**AGENDA**  
**BIRMINGHAM DESIGN REVIEW BOARD**  
**Wednesday - July 6, 2022**  
**BIRMINGHAM CITY HALL, 151 MARTIN ST, COMMISSION ROOM 205, BIRMINGHAM MI \***  
**\*\*\*\*\* 7:15 PM\*\*\*\*\***

**A. 220 Park – Request for façade changes to existing building**

**DATE:** July 6, 2022  
**TO:** Design Review Board  
**FROM:** Nicholas Dupuis, Planning Director  
**SUBJECT:** 220 Park – Design Review

Exterior  
Elevations and  
Plan - Enlarged  
Project Number:

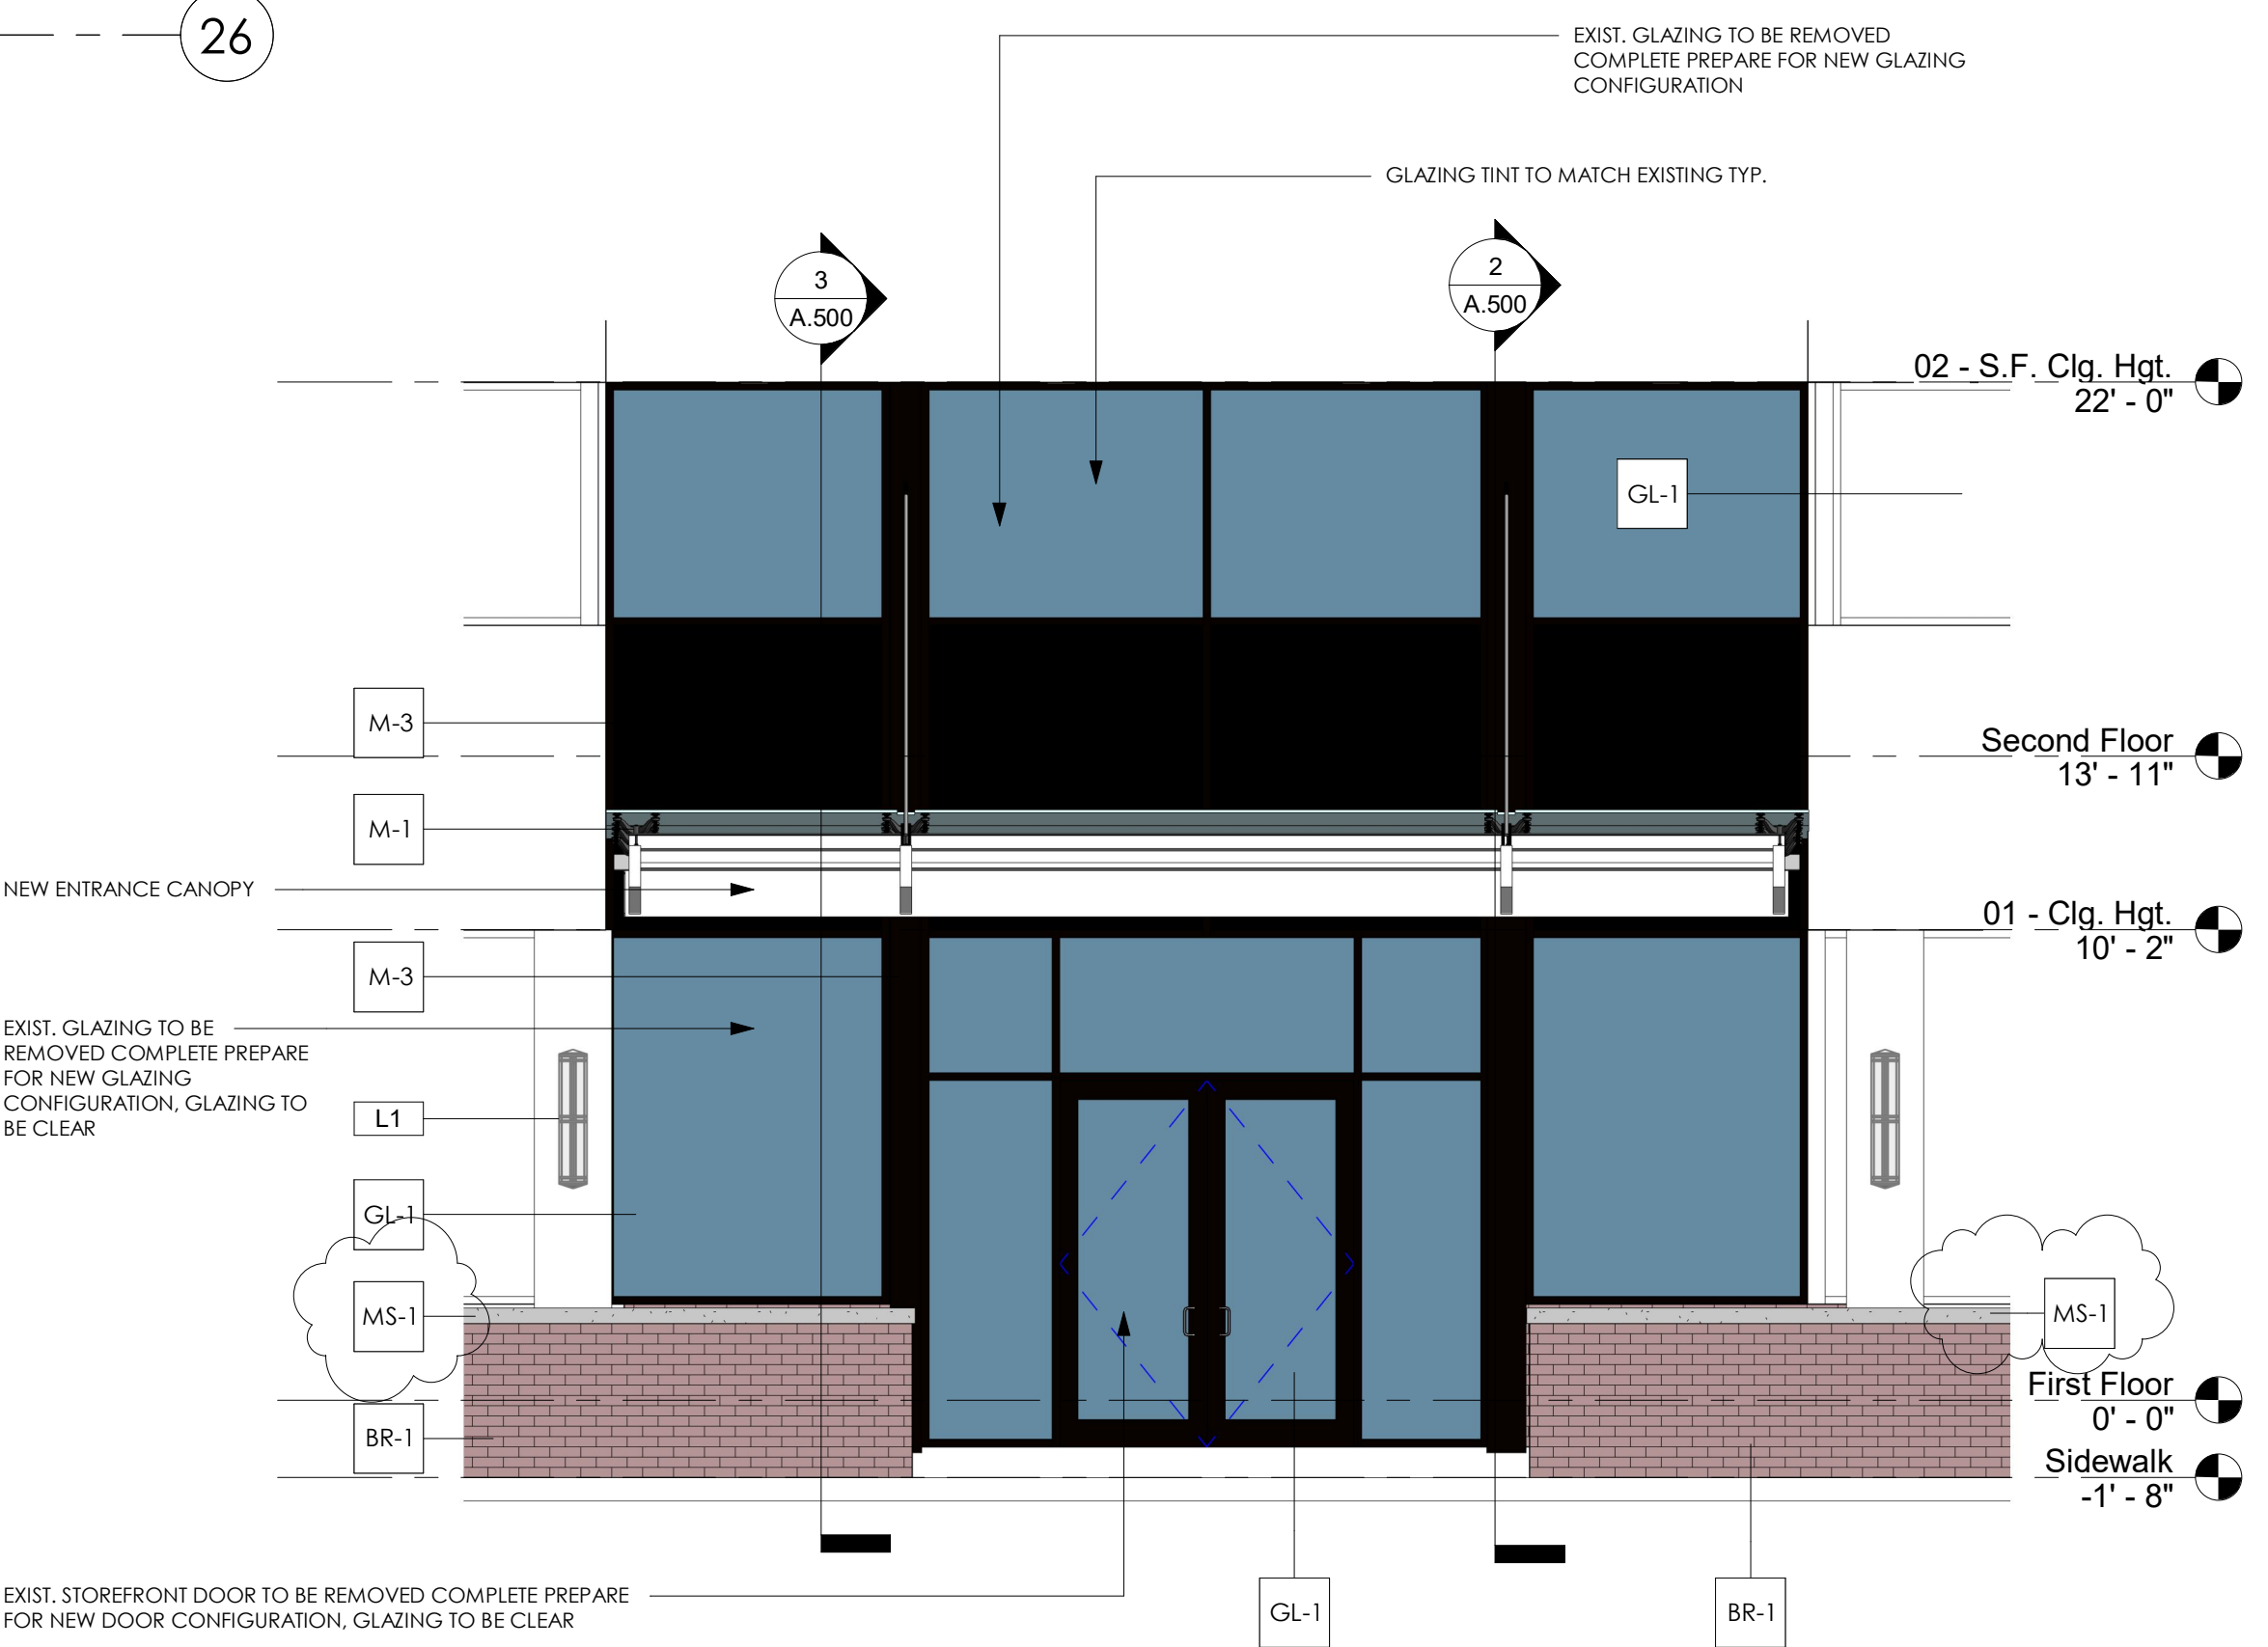
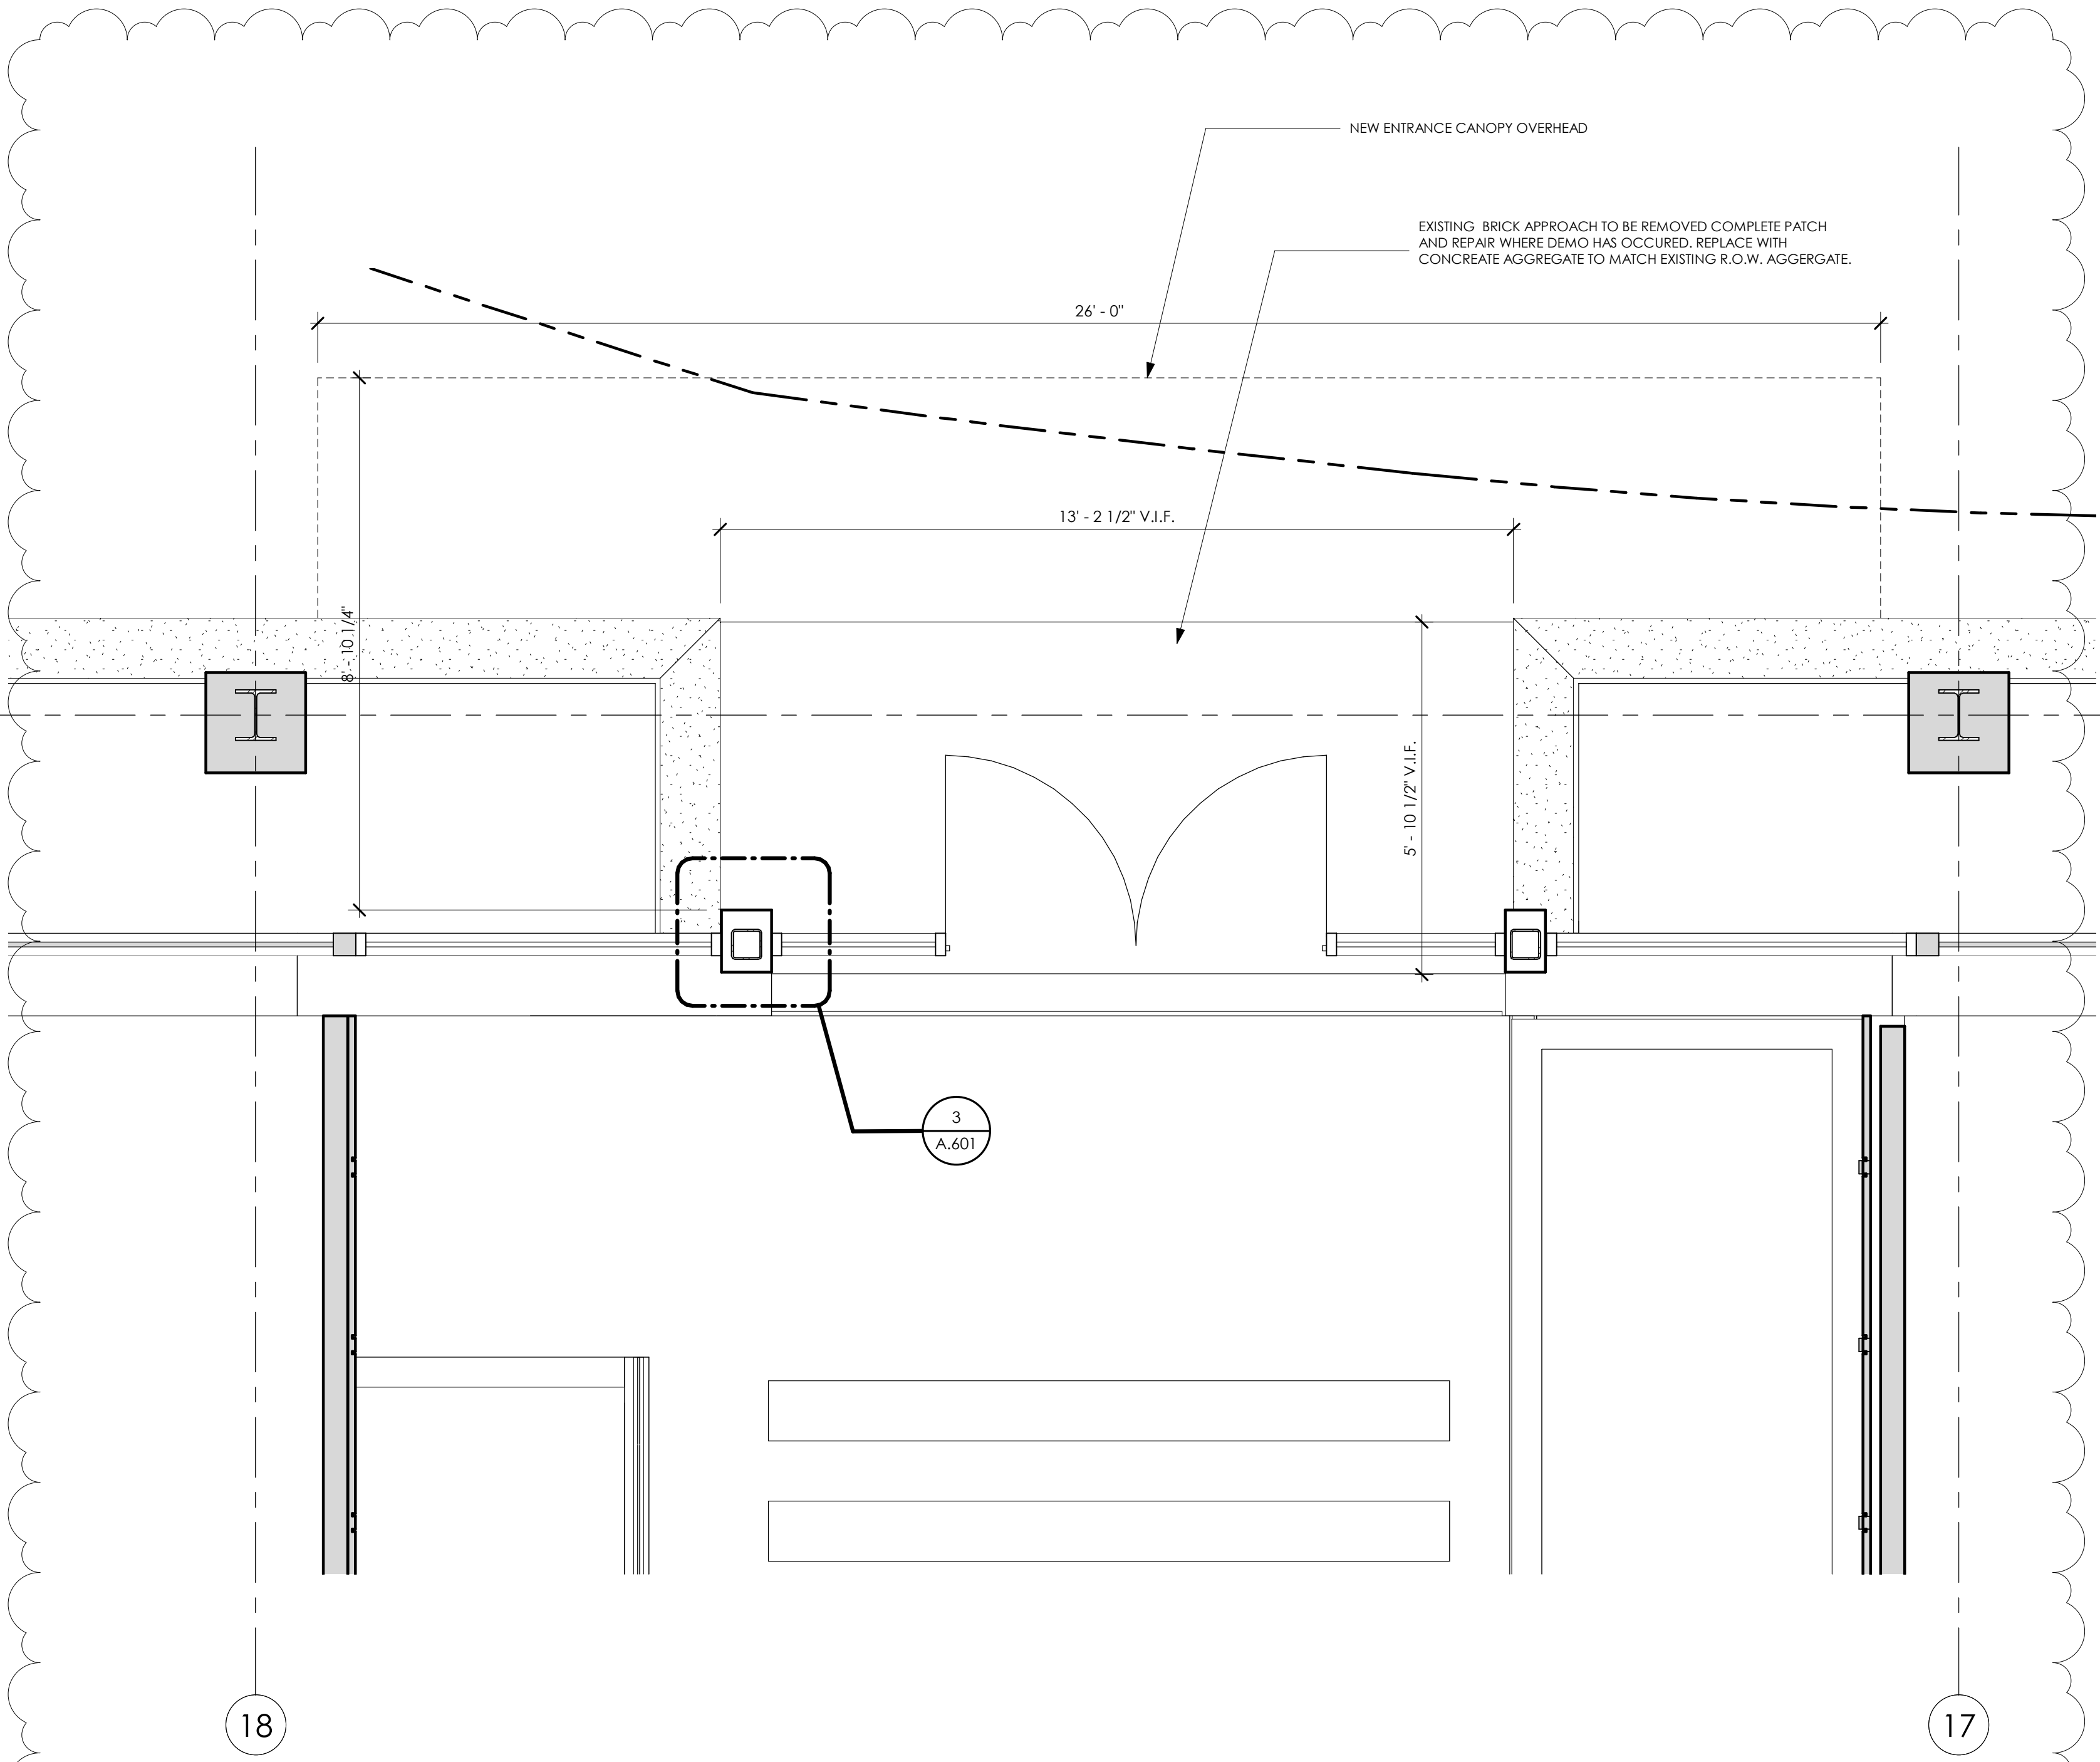
The applicant has submitted detailed drawings of the canopy that indicate a 4 ft. projection into the Park right-of-way. Additionally the applicant has provided a dimension of 11.5 ft. from grade to the bottom of the canopy, which exceeds the minimum of 8 ft. However, it does not appear that the applicant has provided a dimension of the Park sidewalk. Using the scale provided, the sidewalk appears to measure 6 ft., which would permit a projection of 4 ft.
